RE: Addendum No. 2 – Fort Bend County RFP 21-078 Construction of Linear Jail Renovation in Fort Bend County

PROJECT NAME: Fort Bend County - Jail maintenance repairs and renovations

PROJECT NUMBER: RFP – 21-078

ADDENDUM DATE: Thursday, May 13, 2021

SHEET DESCRIPTION: FIRST FLOOR PART C NEW FLOOR PLAN	ISSUED FOR: 100% CD	Issue Date: 04/16/2021
PREPARED BY: 12/11/2020	BD&K Permit Review	SHEET NO. A1-01
SCALE: 1/8" = 1'-0"

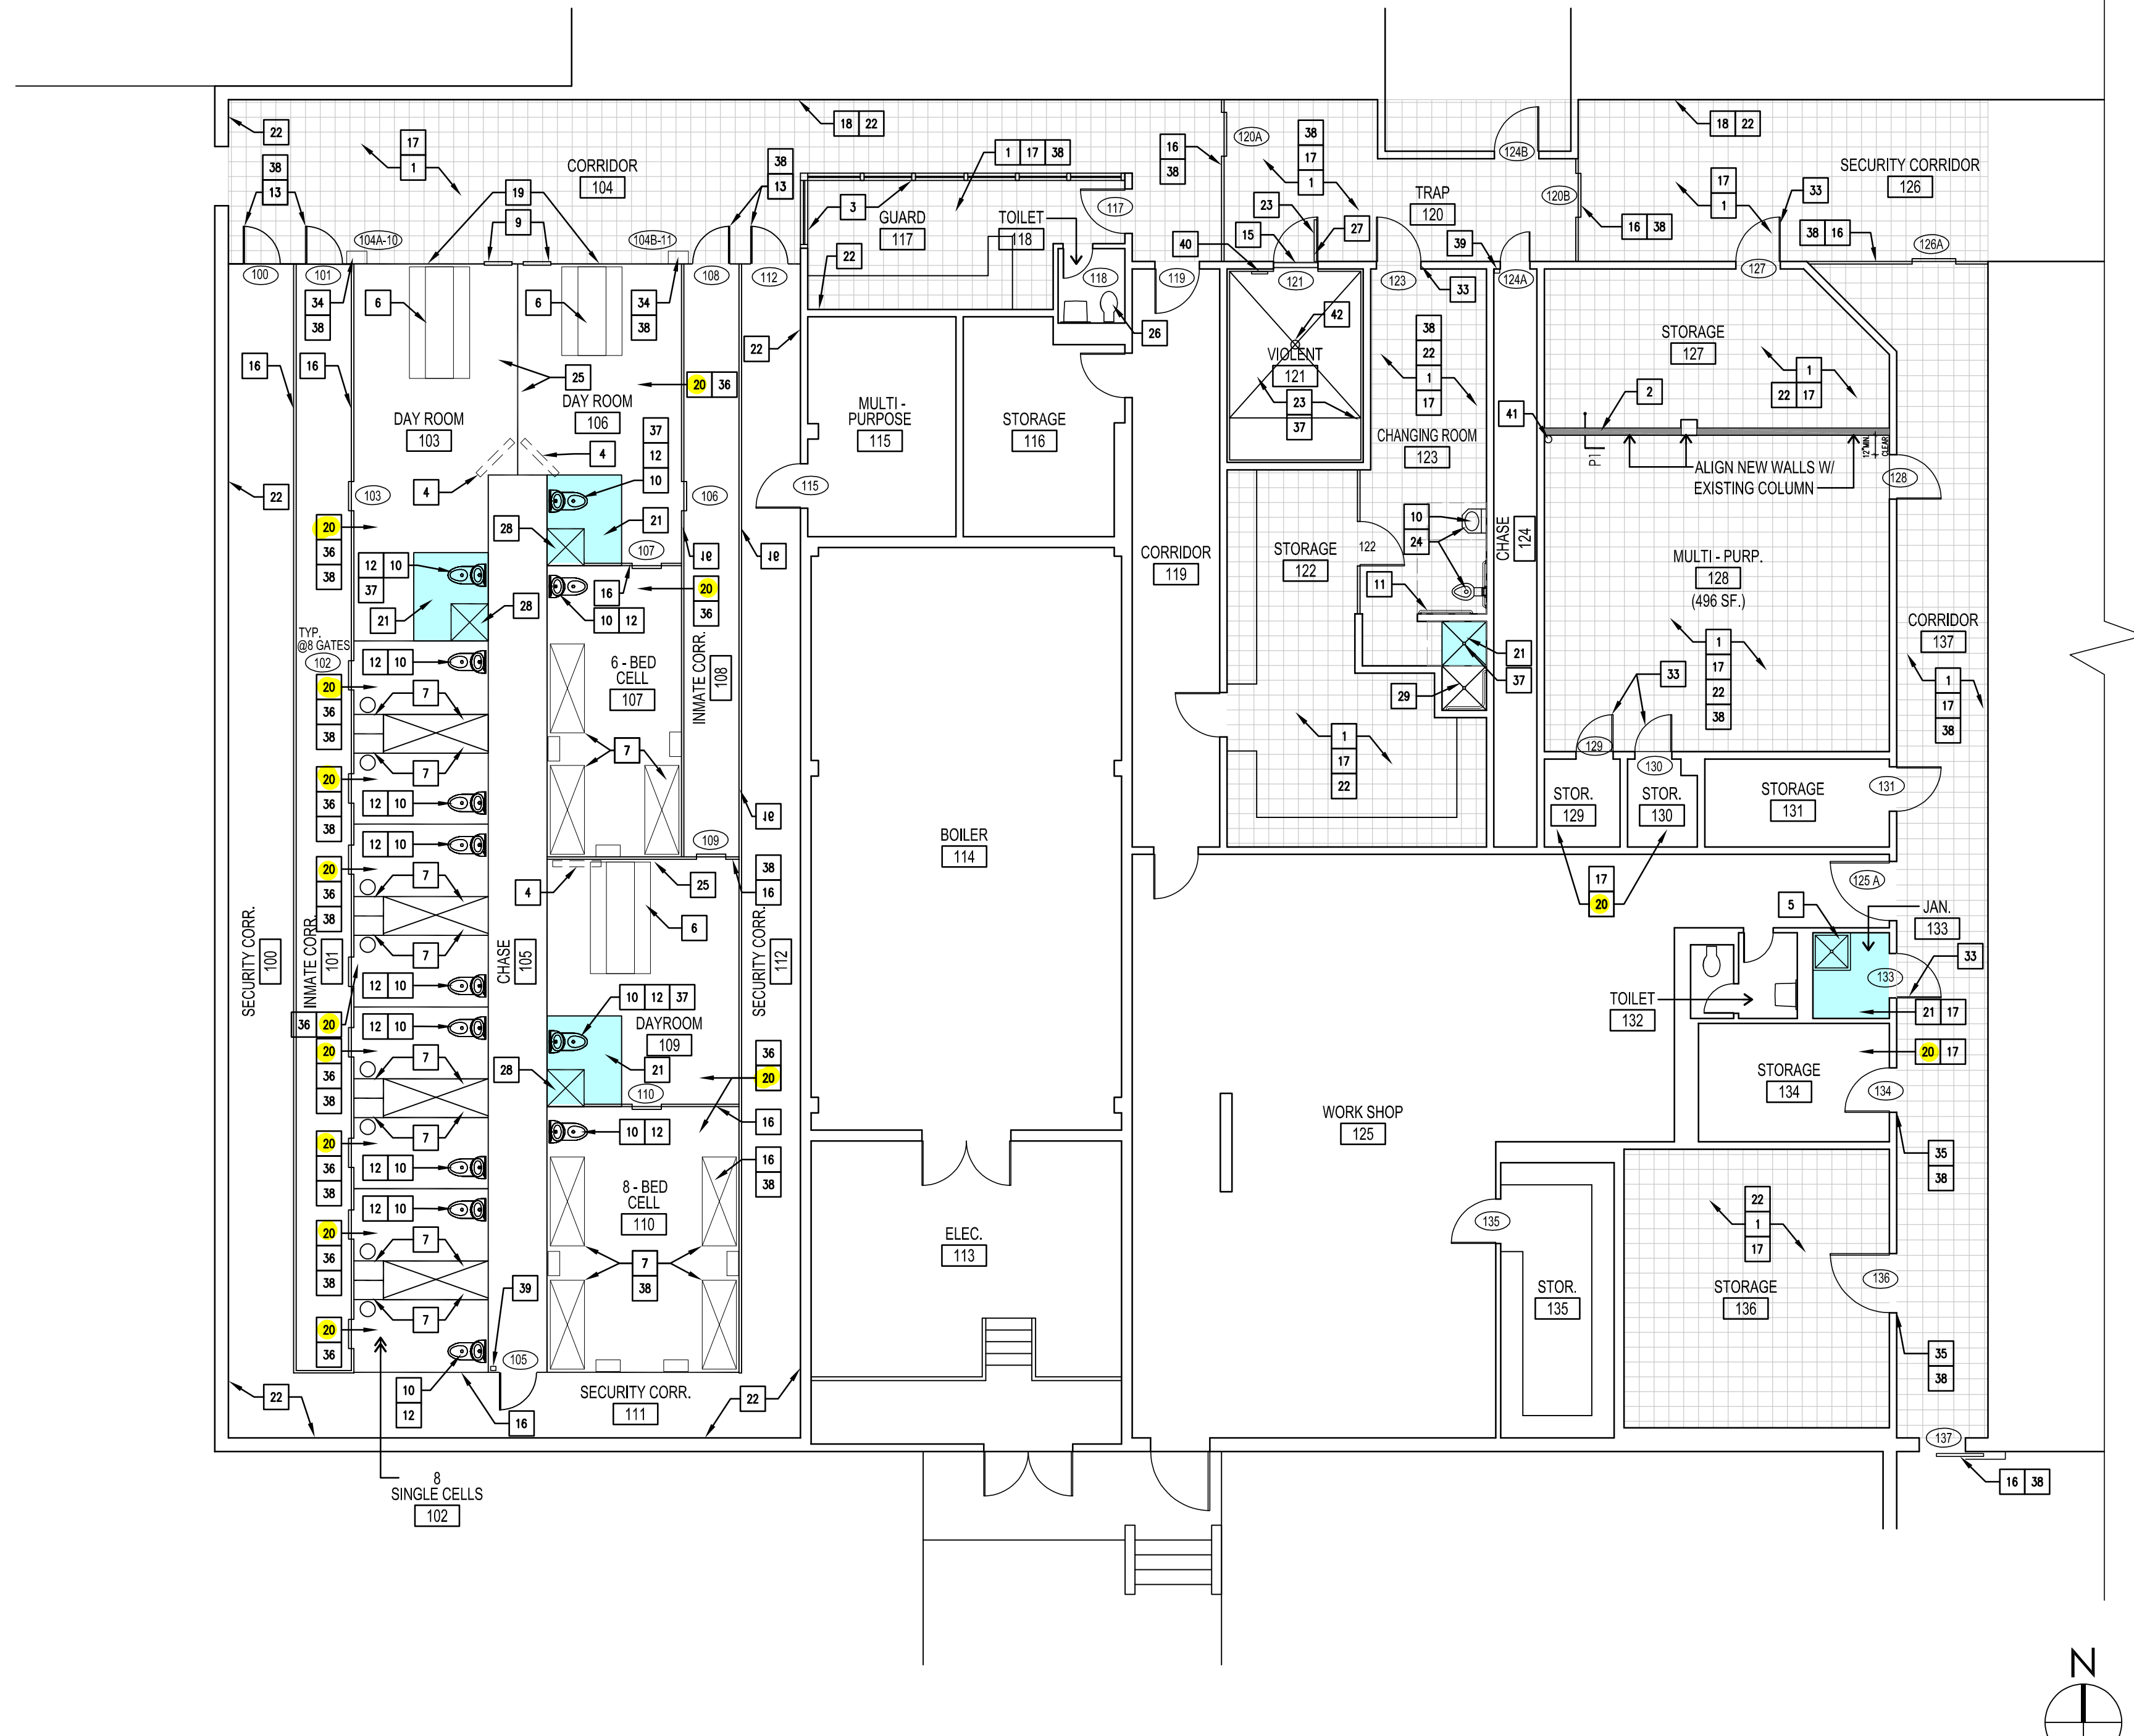
1. There doesn't appear to be a finish schedule or the call out for epoxy in the plans. Please advise.

3. The Scope of Work is specified on sheet A0-30 section 09 67 26 Quartz Flooring. The specification gives reference to Torginol Quartz Blend but does not reference any manufacturers or more importantly the thickness of desired flooring system. Please clarify any manufacturers or thickness for the Quartz Flooring.

[STOA](#): Epoxy is called out on the plans on sheet A1-01, A1-03, and A1-05. (Outlined areas indicated as Keynote 1, 20, and 21.) Refer to the legend indicates the epoxy quartz shown as:

STOA: 40-S grade Quartz floor epoxy is used for lighter duty systems at 1/8" thickness. Epoxy is called out on the plans on sheet A1-01, A1-03, and A1-05. (Outlined areas indicated as Keynote 1, 20, and 21.) Refer to the legend indicates the epoxy quartz shown as:

Per Note 20 Epoxy
flooring
(At Cells, Dayrooms,
holding cells typical)

ISSUED FOR: 100% CD	Issue Date: 04/16/2021
8036 Permit Review	
12/11/2020	SHEET NO. A1-03
SCALE: 1/8" = 1'-0"

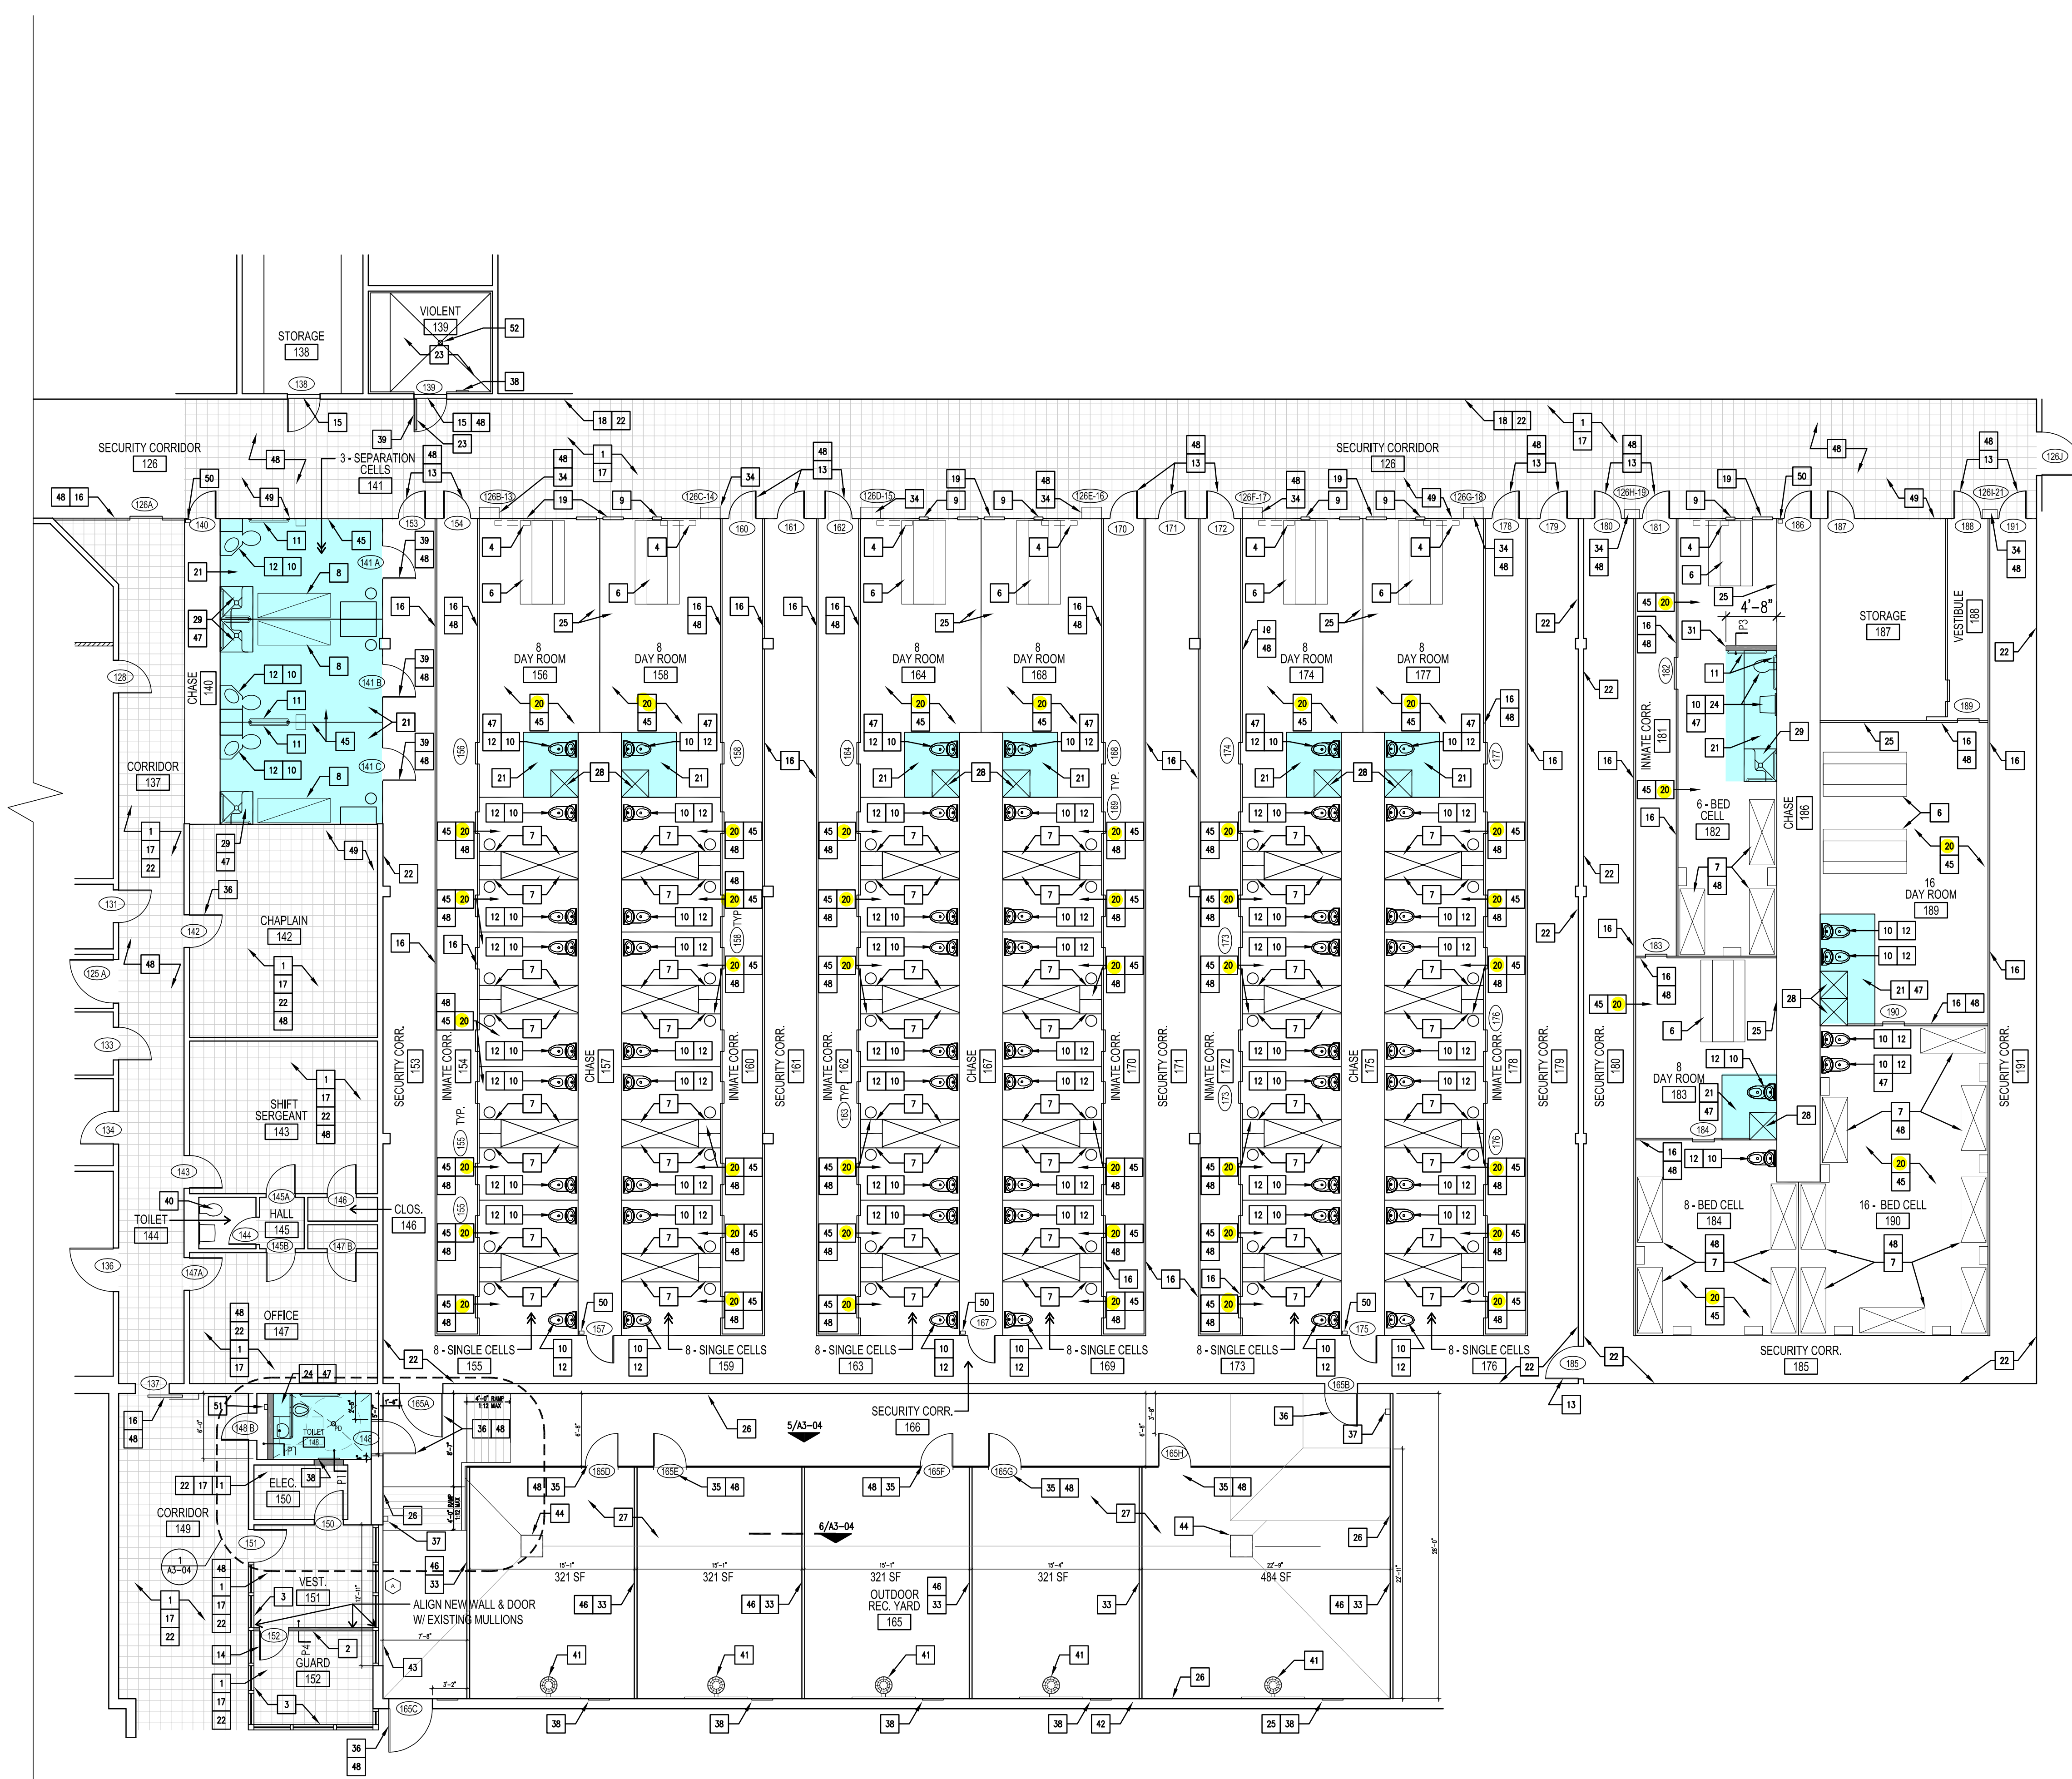
2. Fort Bend County A1.03 Note 46 - Is the County requesting GPR scanning for the designated concrete? Please advise.

STOA: Yes, GPR scanning being requested for the designated concrete in the outdoor rec yard 165; to prevent any damage to any existing utilities and existing unknown structure components underneath at the new fence post locations and ramp areas.
